# Review of the separation dipole D1

Ezio Todesco, CERN

CERN, 4th August 2016

# Review panel

Coil unloading during powering of the first D1 short model [M. Sugano, T. Nakamoto, et al.]

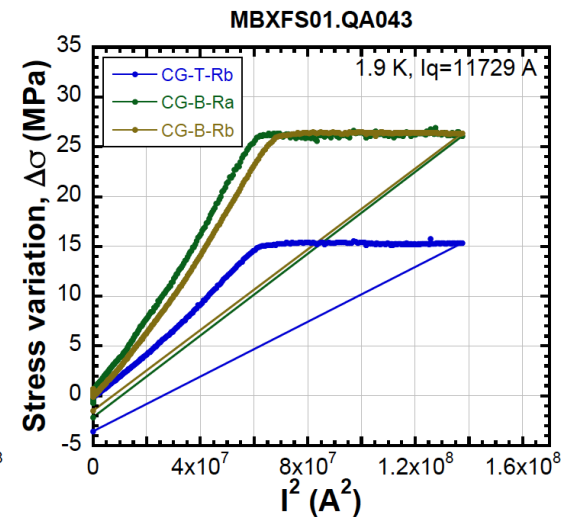
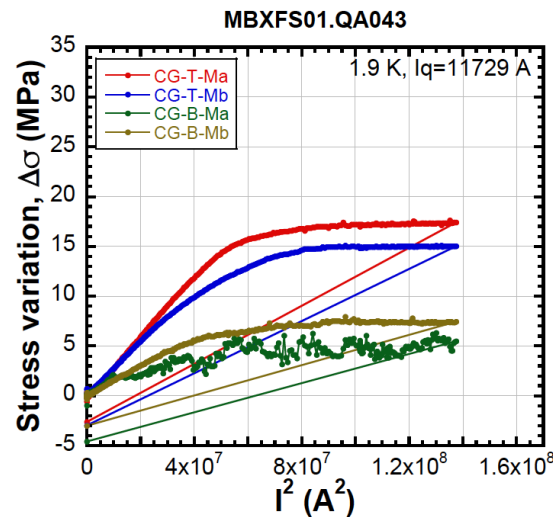
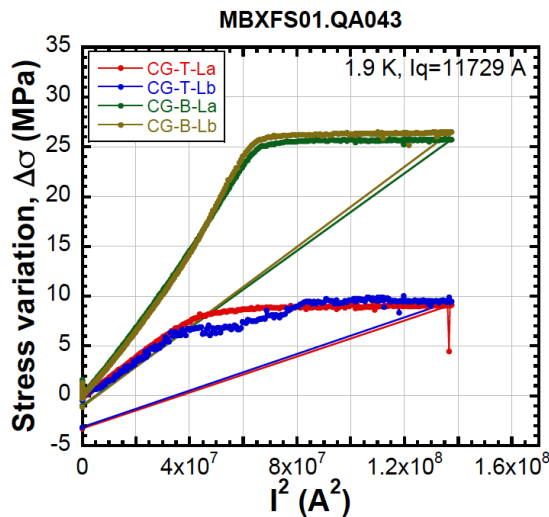
- Clear evidence of coil unloading at 8.5 kA (nominal is 12 kA)
  - Larger prestress loss than expected during cool-down
  - Not clear if quenches are in the heads or in the straight part

Model and measurements of transfer function and  $b_3$  [M. Sugano, T. Nakamoto, et al.]

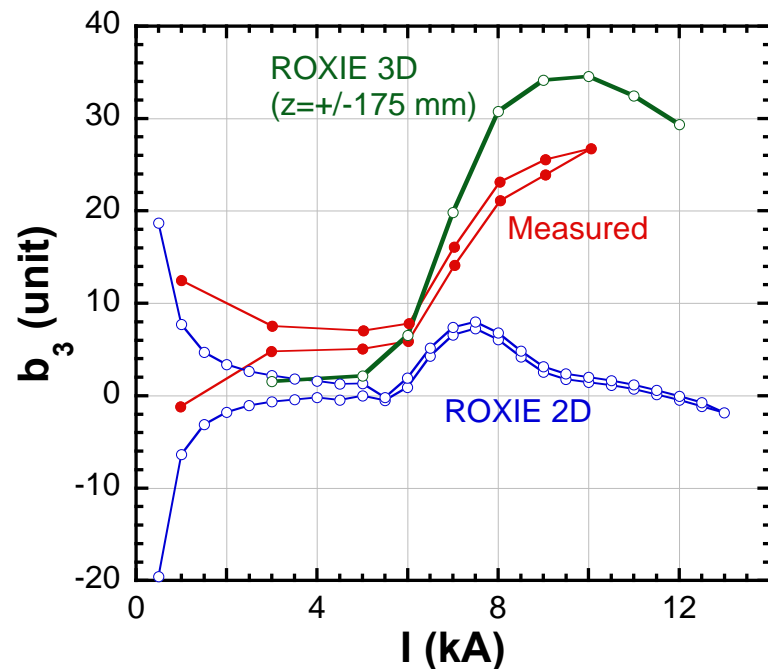
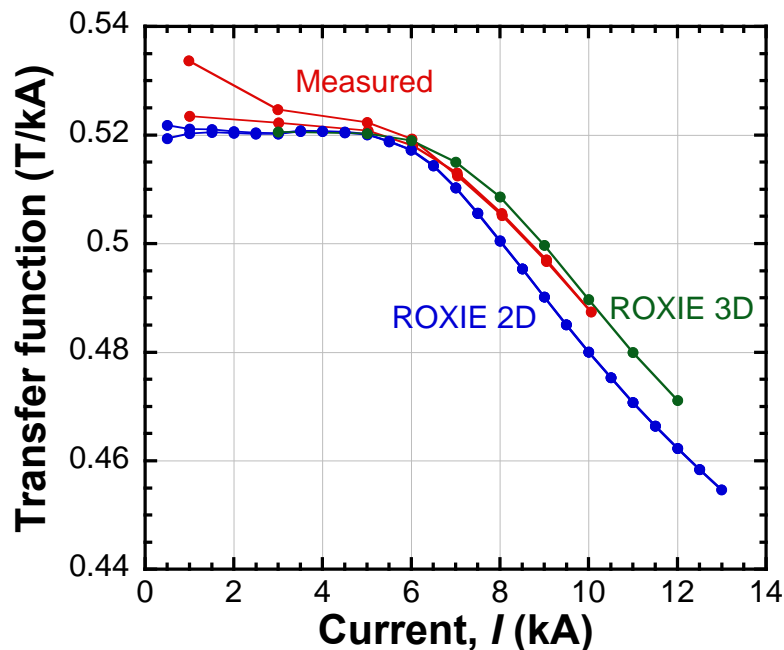
- Geometric  $b_3$  was centered within 5 units
  - This can be considered as normal, to be recovered with shimming of the coil in the production
- Large impact of coil ends on  $b_3$  saturation in the straight part – to be understood

Old (left and possible new (right) position of the HX holes [M. Sugano, T. Nakamoto, et al.]

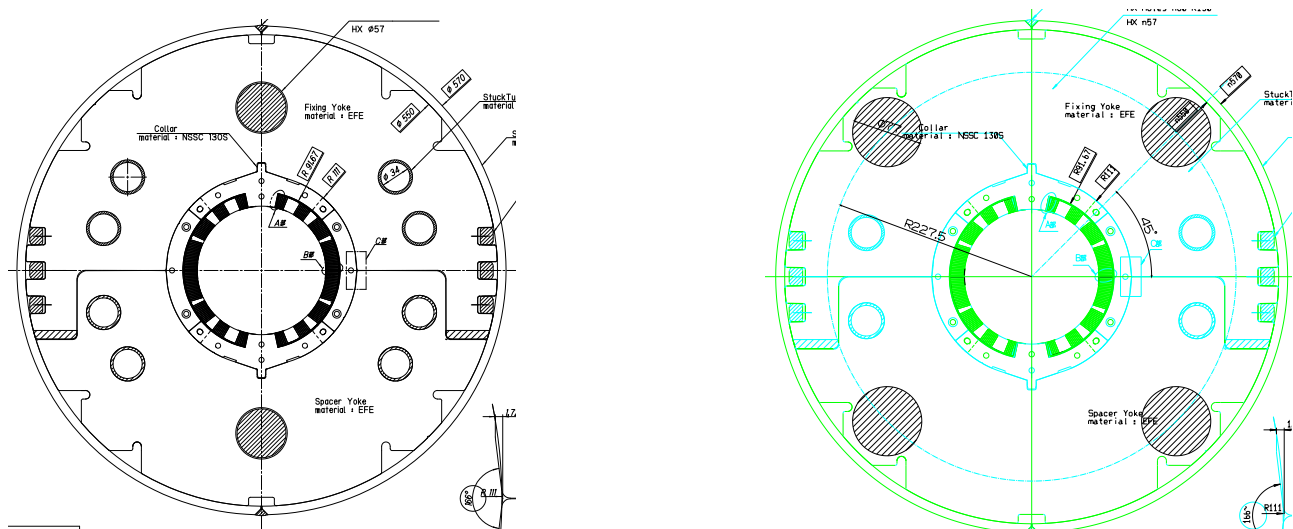
- Recently it has been realized that heat exchangers in the triplet and in D1 has to be in the same longitudinal position [H. Prin, D. Duarte Ramos, July 2016]
  - This implies putting the holes at 45 (larger saturation) and redesign the iron
  - Moreover, these holes would be very close to the shell
    - We could have to increase the yoke diameter – major change
